Access Compliance Report

Public Rights-of-Way

(Curb Ramps)

Intersection ID: 11521	Main Street: W_11TH_ST	Cross Street: N_CHURCH_ST	Location: S
ADA ID: 99C7E9E5E61C	Ramp Type: PerpDiag	Initial Pass/Fail: Pass	Overall Compliance: No
			Severity Score: 27.75

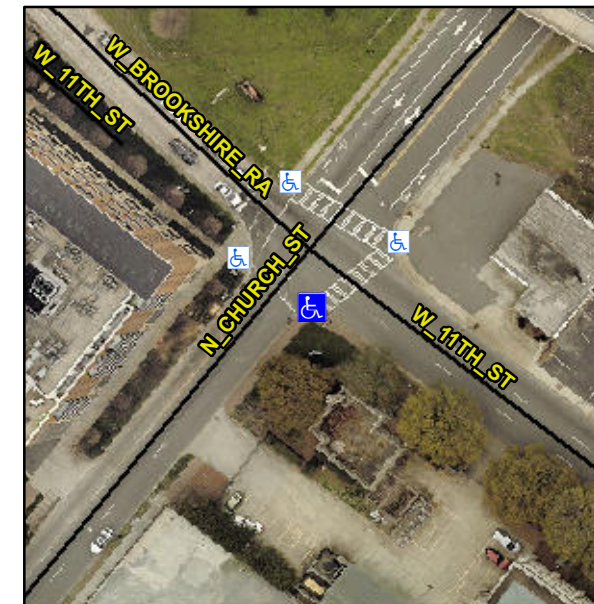
Not Found, R304.5.3, R304.2.1, R304.2.2-Perp, R304.3.2-Para, R304.2.3, R305, R304.5.4

Compliance	Description	Data	Compliance	Description	Data
N/A	Ramp Length (in)	70.0	Yes	Ramp Slope (%)	5.3
Yes	Ramp Width (in)	50.0	No	Ramp XSlope (%)	2.4
N/A	Flare Type LT	Sloped	N/A	Flare Type RT	N/A
N/A	Flare Slope LT (%)	9.9	No	Flare Slope RT (%)	10.4
N/A	Flare Traversable LT?	Yes	N/A	Flare Traversable RT?	Yes
No	Landing Length (in)	N/A	No	DWS Provided?	No
No	Landing Width (in)	N/A	N/A	DWS Contrast?	No
No	Landing Slope (%)	N/A	N/A	DWS Length (in)	N/A
No	Landing X Slope (%)	N/A	N/A	DWS Full Width?	No
N/A	Landing Curb? (Y/N)	No	N/A	DWS Offset (in)	N/A
N/A	Shared Landing?	No			
Yes	Gutter Ponding?	No	No	Gutter Slope (%)	6.4
Yes	Gutter Lip Ht (in)	0.0	No	Gutter X Slope (%)	2.8
N/A	Painted X Walk1?	Yes	N/A	Painted X Walk2?	Yes
	X Walk 1 Direction	To NE		X Walk 2 Direction	To NW
N/A	X Walk 1 Width (in)	101.0	N/A	X Walk 2 Width (in)	102.0
	X Walk 1 Slope (%)	0.2		X Walk 2 Slope (%)	3.7
	X Walk 1 X Slope (%)	2.0		X Walk 2 X Slope (%)	2.0

Yes	Ramp inside XWalk1?	Yes	Yes	Ramp inside XWalk2?	Yes
	Road Slope (%)	0.1	N/A	Clear Space?	Yes
	Road X Slope (%)	1.8	No	Clear Space to XWalk (in)	38.0
Yes	Any Obstructions?	No	Yes	Storm Grate/Utility Hazard?	No
	Obstruction Type			Storm Grate/Utility Type	
		N/A			N/A
			Yes	Surface Condition? (G/P)	Good

Remove & Replace Curb Ramp With Two New Directional Ramps or Equivalent. Restripe Crosswalk(s) To Provide Clear space. Remove & Replace Gutter.
